BUILDING NO. 2 DRIVE THROUGH AT NOVI TOWN CENTER JSP17-08

Consideration at the request of Novi Town Center Investors, LLC for Building No. 2 Drive Through at Novi Town Center JSP 17-08, for Planning Commission's recommendation to the City Council for approval of Special Land Use Permit, Preliminary Site Plan and Storm Water Management Plan. The subject property is zoned Town Center District (TC). It is located in Novi Town Center in Section 14, on the northeast corner of Grand River Avenue and Novi Road. The applicant is proposing to reconstruct the existing parking lot on the southwest end of Novi Town Center in order to construct a drive-through lane for a future coffee shop. A 48 square foot addition along with outdoor seating is also proposed. A Special Land Use Permit is required in order to permit Drive-Through restaurants in the TC Town Center District.

PLAN REVIEW CENTER REPORT

Preliminary and Final Site Plan and Stormwater Management Plan

**DIMENSION AND PAVING PLAN
BUILDING NO. 2 DRIVE-THRU**

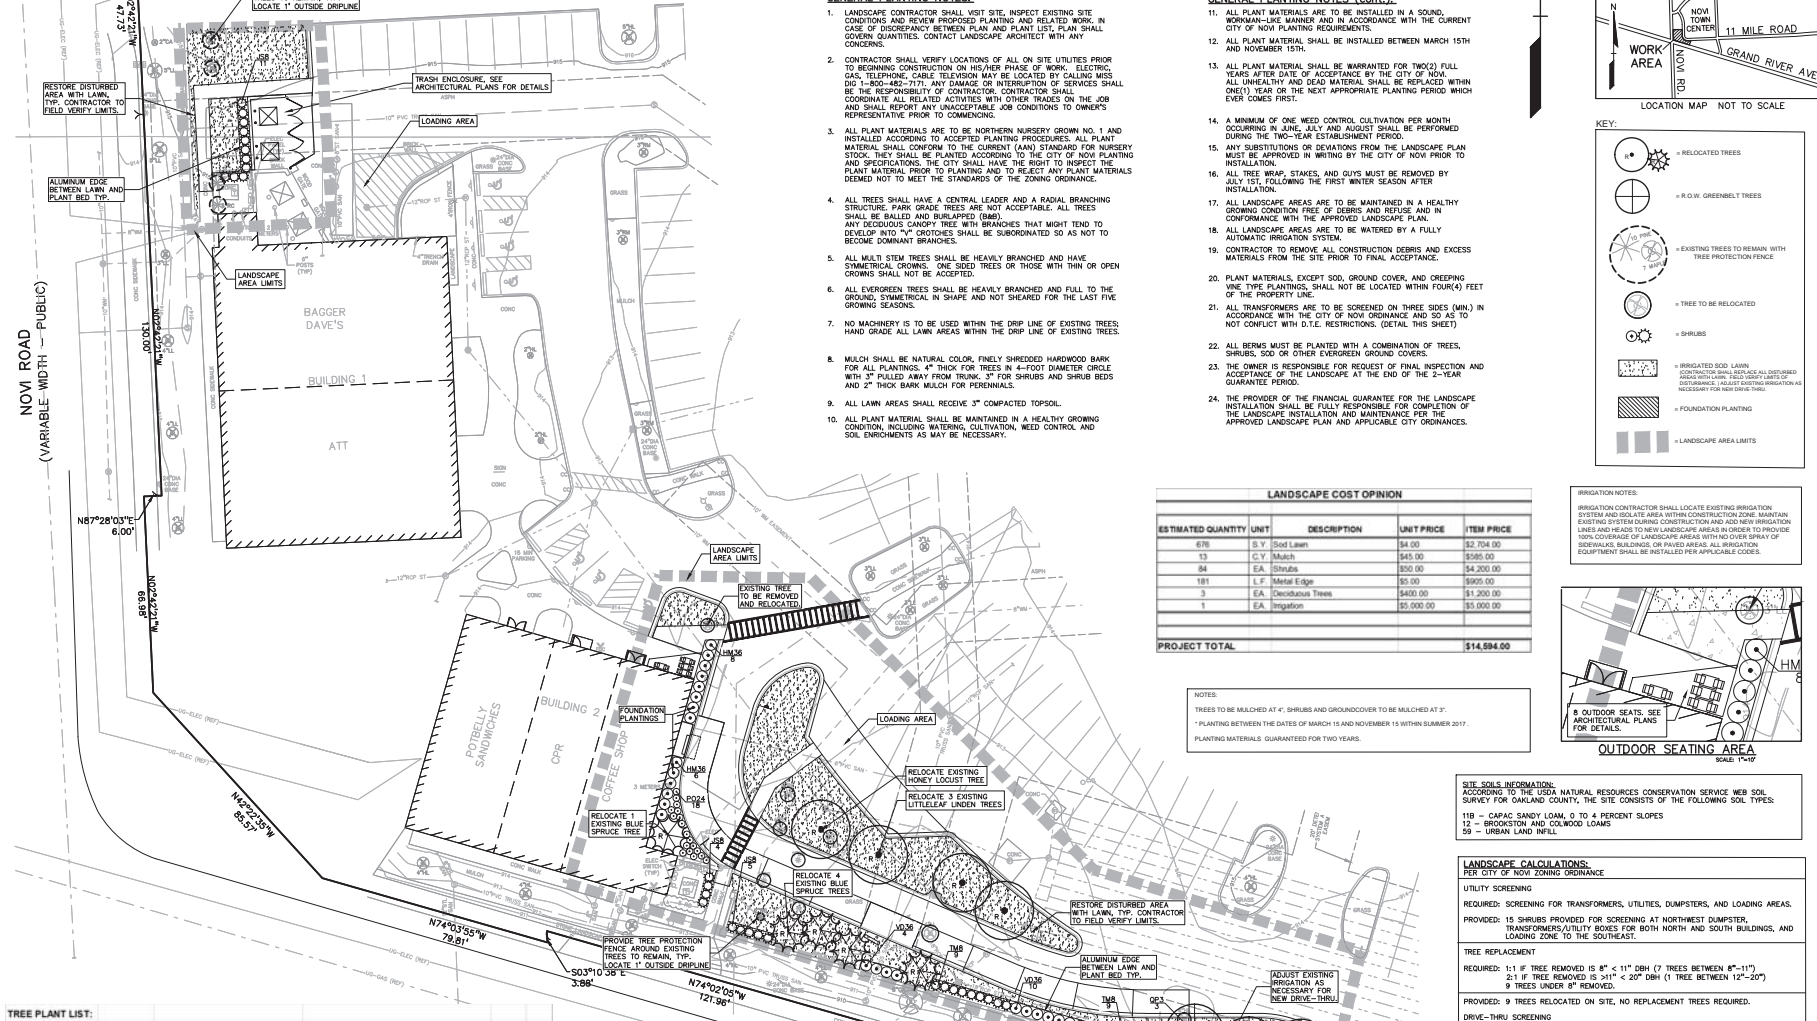
1. Sheet C-4: Locate the proposed drive-thru menu board outside of the existing sanitary sewer easement. Show a portion of said easement on the same plan sheet as a reference relative to the menu board location.

2. **Sheet C-4: Locate the proposed trash enclosure wall foundation outside of the existing sanitary sewer easement. Show a portion of said easement on the same plan sheet as a reference relative to the trash enclosure wall location.**

From: Matt Niles [mailto:mniles@wahyeeassoc.com]
Sent: Monday, May 01, 2017 4:10 PM
To: Komaragiri, Sri
Cc: JClear@simon.com; Jon Curry; Jacob Holda; CFOSSE@WAHYEEASSOC.COM
Subject: Drive-Thru Window At Novi T.C. : Dumpster Enclosure Wall Proposal

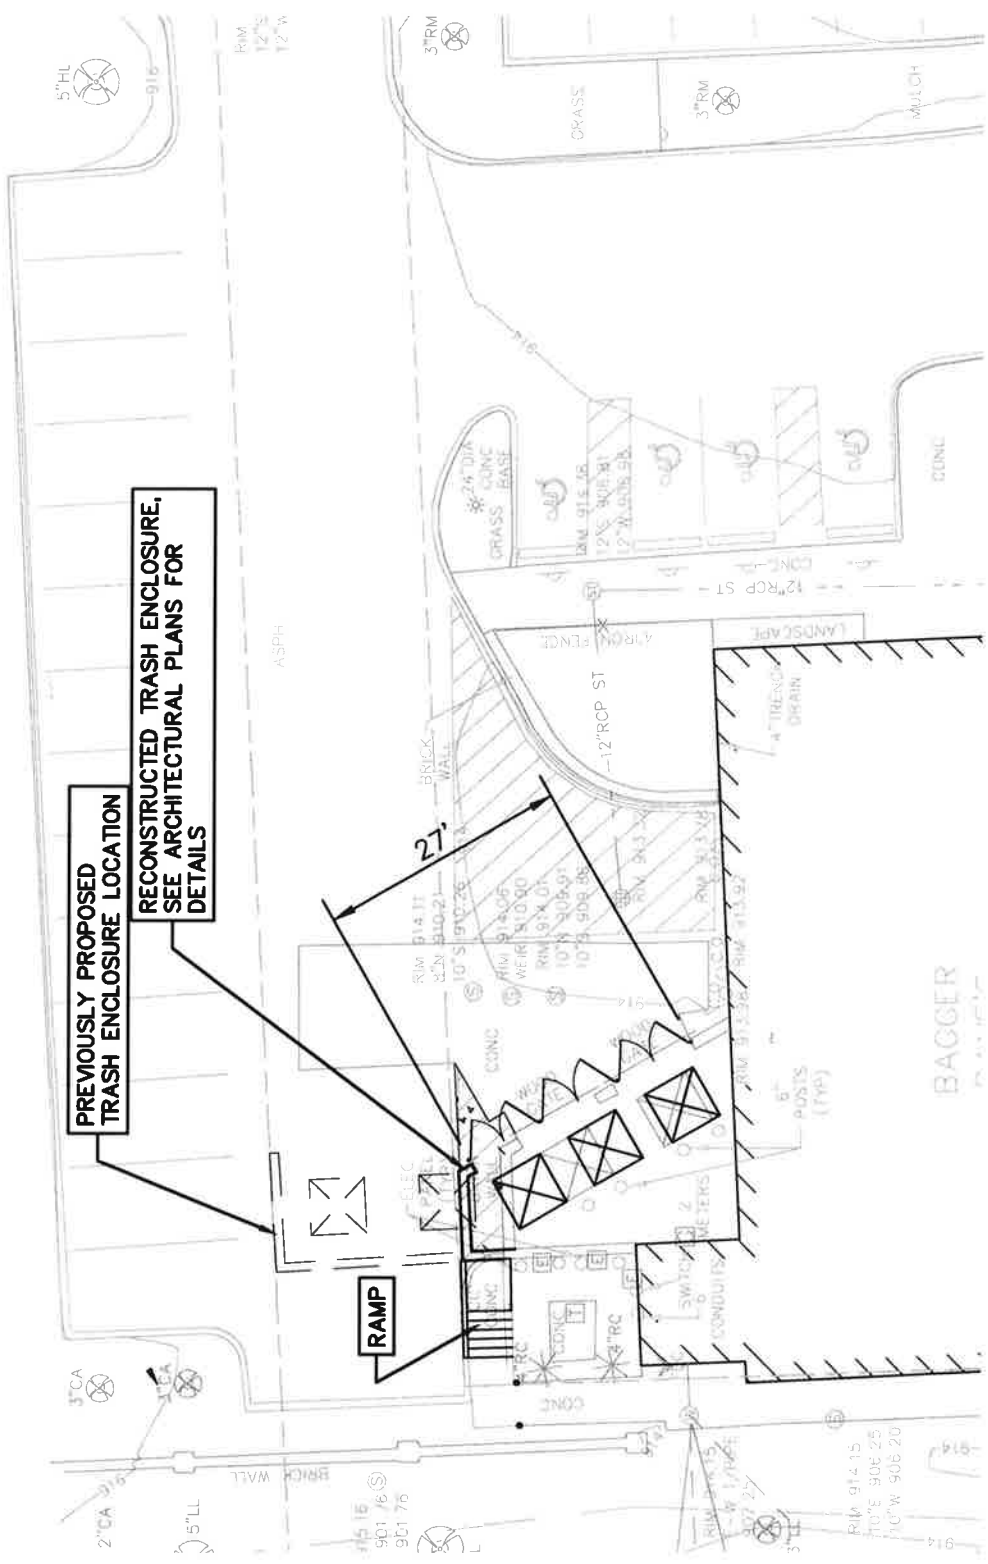
1. Noise Impact Statement:
2. Dumpster Location: **The proposed dumpster location conflicts with the parking spaces and sanitary sewer easement. Refer to Engineering and Traffic review for more details**
3. Plan Review Chart: **Refer to other minor comments in Plan Review Chart for more information requested with the electronic stamping set**

Attached is our proposal for resolving the issues with the new dumpster enclosure. Instead of building a new structure, we propose to just expand the existing enclosure a little to the north to accommodate one more dumpster. This should eliminate the conflict between parked cars and a truck servicing the dumpsters, but we can add the note designating these spaces as "employee spaces" if you still think that is needed. This also gets the enclosure off of the 10" sanitary easement. In this option, there will be one less dumpster than previously proposed, but we can resolve this by having the dumpsters serviced a little more often as needed. This proposal is actually much better than before as the overall dumpster enclosure will be smaller. Please see the attached plan. I would like to talk to you still today if possible to make sure that we will still be on the May 24th Planning Commission, and if there is anything else that you will need from us such as a revised submittal plan and or elevations incorporating this.
